SUBJECT: ENVIRONMENTAL ASSESSMENT OF THE APPLICATION OF ALTERNATE  
CONCENTRATION LIMITS TO GROUND WATER AT THE UMETCO MINERALS  
CORPORATION, GAS HILLS URANIUM MILL SITE (TAC NO. L51785)

ENVIRONMENTAL ASSESSMENT  
FOR  
UMETCO MINERALS CORPORATION'S URANIUM MILL SITE  
EAST GAS HILLS, WYOMING

IN CONSIDERATION OF AN AMENDMENT TO  
SOURCE MATERIAL LICENSE SUA-648 FOR  
ALTERNATE CONCENTRATION LIMITS  
FOR GROUND WATER

FIGM-15 B & W.DWG

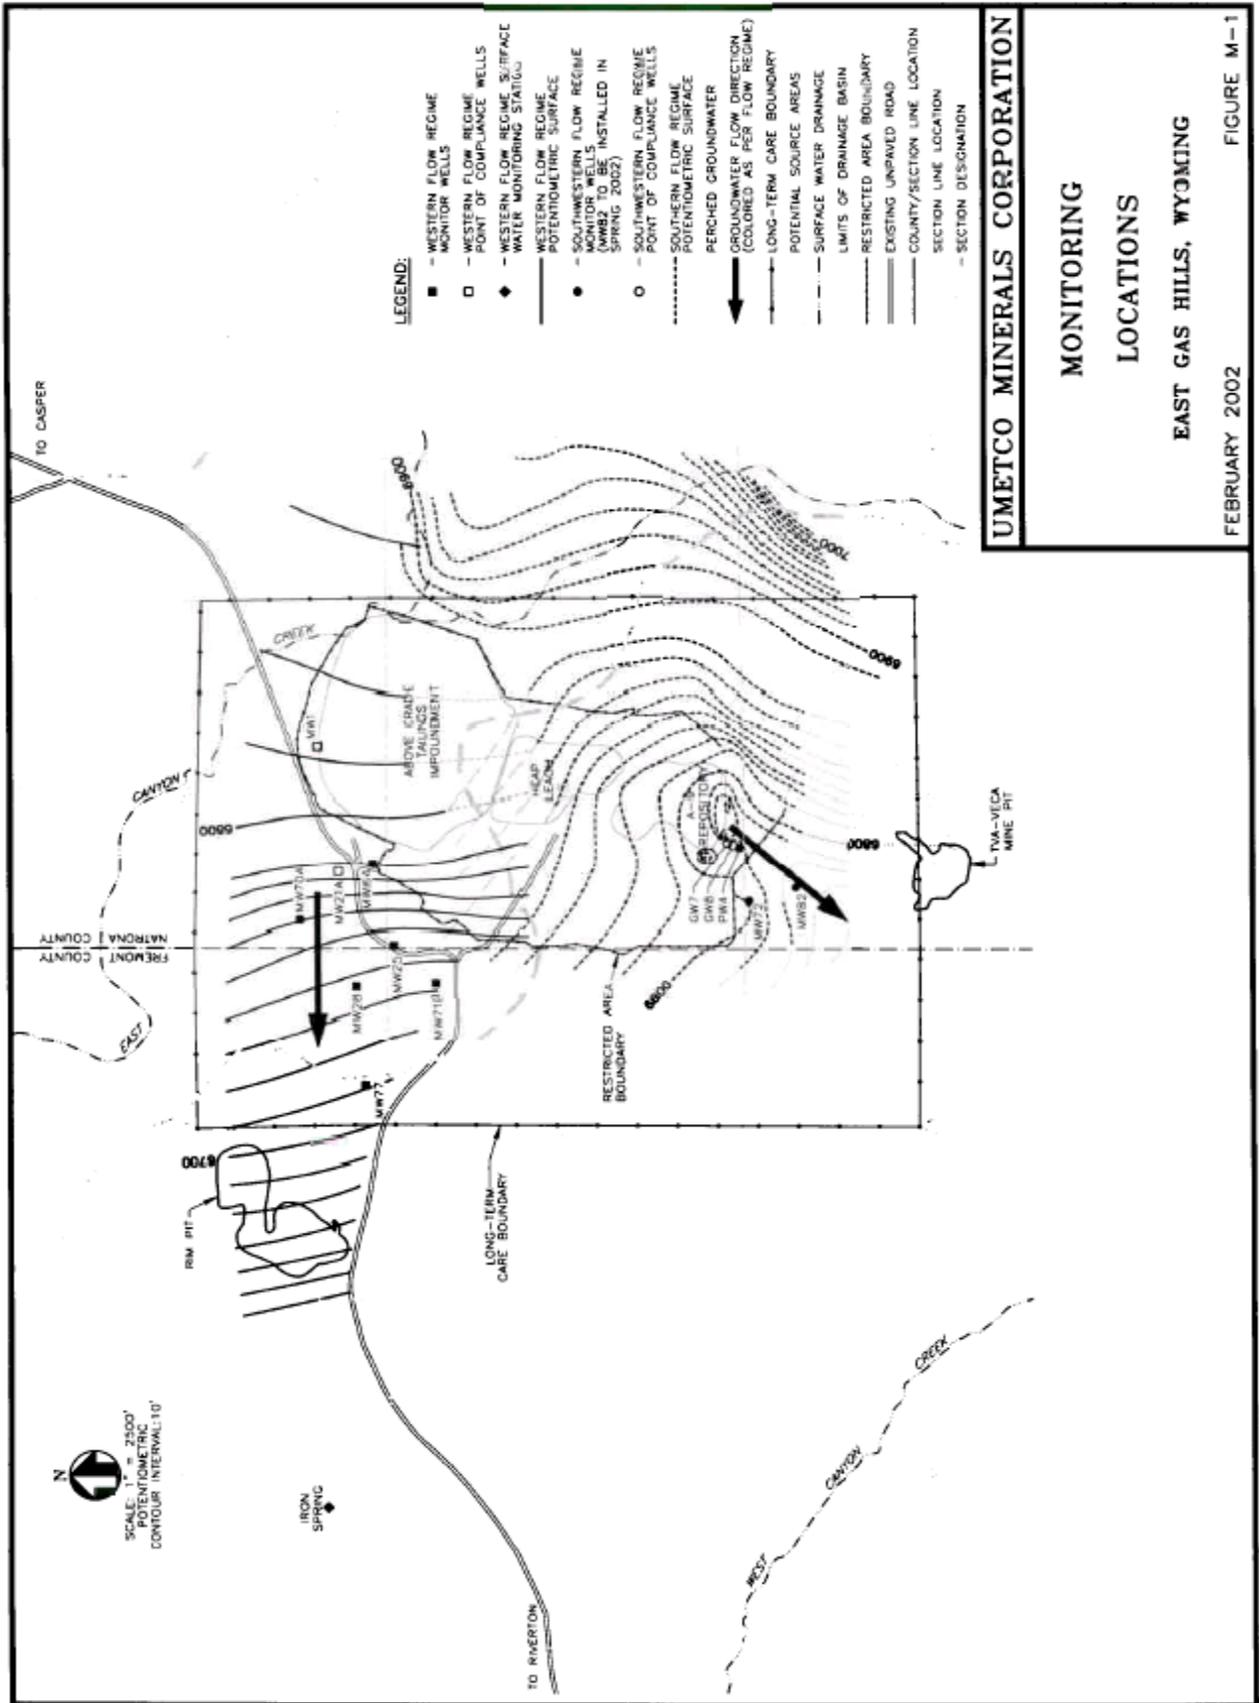
Comment - Section 3.0, item 3, does not identify the monitoring well locations. Also, POE locations should be monitored.

Response - A figure has been added to the end of the EA indicating monitoring locations. Since one of the more mobile constituents, sulfate, is not expected to increase noticeably at the POE for many years (in Western Flow Regime, 300 mg/l at 10 years with peak at 78 years, in Southwestern Flow Regime, 100 mg/l at 40 years with peak at 100 years), and Umetco will terminate its license in 3 or 4 years, Umetco will not be required to have monitoring wells at the POE for approval of the ACL request. However, it is anticipated that before license termination, DOE will require Umetco to install wells near the POE along the paths of the plumes, for monitoring under the LTSP.
